UNITED STATES
DEPARTMENT OF THE INTERIOR
BUREAU OF LAND MANAGEMENT

SUNDRY NOTICES AND REPORTS ON WELLS
Do not use this form for proposals to drill or to re-enter an abandoned well. Use form 3160-3 (APD) for such proposals.

1. Type of Well <input type="checkbox"/> Oil Well <input checked="" type="checkbox"/> Gas Well <input type="checkbox"/> Other	8. Well Name and No. LAKE SHORE SC 10 FEDERAL COM 4
2. Name of Operator FASKEN OIL AND RANCH LTD. Contact: ADDISON LONG E-Mail: addisonl@forl.com	9. API Well No. 30-015-31569
3a. Address 6101 HOLIDAY HILL ROAD MIDLAND, TX 79707	3b. Phone No. (include area code) Ph: 432-687-1777
4. Location of Well (Footage, Sec., T., R., M., or Survey Description) Sec 10 T21S R26E NWNW 1310FNL 1160FWL	10. Field and Pool or Exploratory Area AVALON-DELAWARE Upper Penn. 7/1000 11. County or Parish, State Avalon W.P.M.P. 7/1120 EDDY COUNTY, NM

Lake Shore Fed S C 10 4
30-015-31569
Fasken Oil & Ranch Limited
August 08, 2017
Conditions of Approval

Proposed 5-8-17

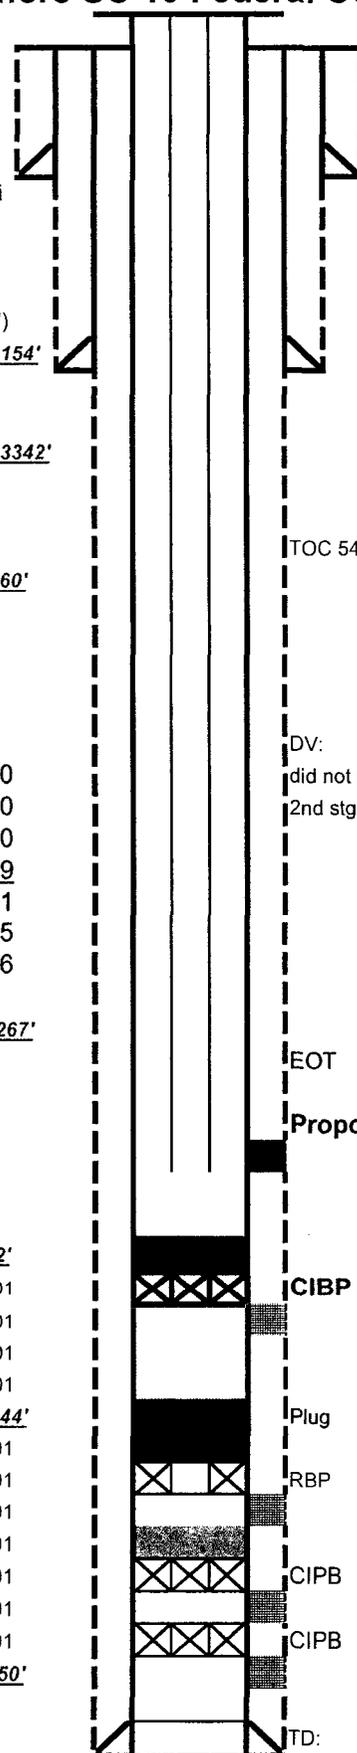
- 1. Operator shall tag RBP at 10,492' and place Class H Cement on top tagging at 10,157' as proposed to seal the Morrow formation.**
- 2. Operator shall place CIBP at 9610' and place 35' Class H cement as proposed. WOC and tag.**
- 3. Squeeze approved as written. If MIT fails contact BLM. Submit MIT chart with subsequent report.**
